This is a typical Item Report Page (IRP) layout from Clouder & Associates.
IRP's can be designed or cloned to suit the clients requirements. ARC

Client "Confidential Drilling Ltd." Month, Year.
Facility "No-name" drilling package working off Malaysia for "OilCo."
Location Just outside of eating mess.
Equipment DISTRIBUTION PANEL 3.
Component C/B 7 TOP TERMINATION.
Item Report Page. Survey by Anthony Clouder, Tel:+6013-8330093. 14/03/01-10:22 IRP 12.

FAULTY TERMINATION AT C/B 7 TOP.

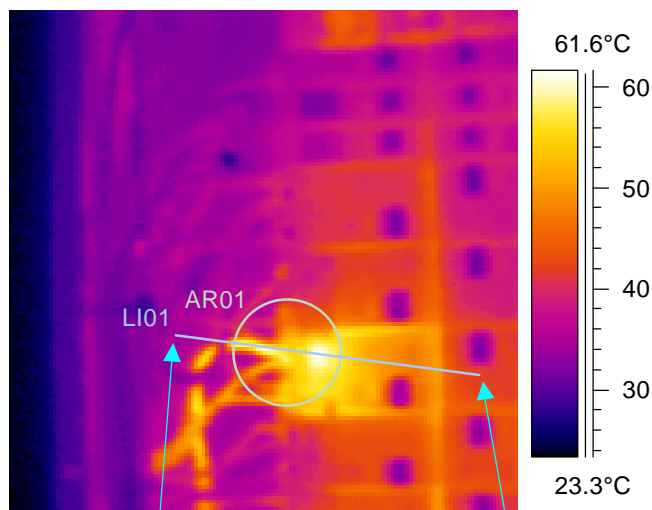
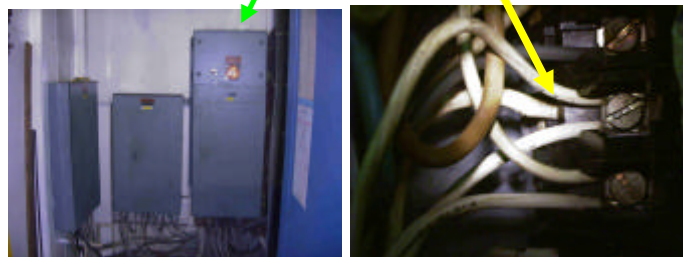
Label	Value
AR01 : max	61.5°C

REMARKS: -
SERIOUS.
27C overheated.
Ultrasound: No additional faults detected.

This is due to one of the wires under the same single screw being loose.
The heat generated or sparking may soon cause C/B damage and /or tripping.
The current and C/B are within correct specifications. Suggest Re-termination.
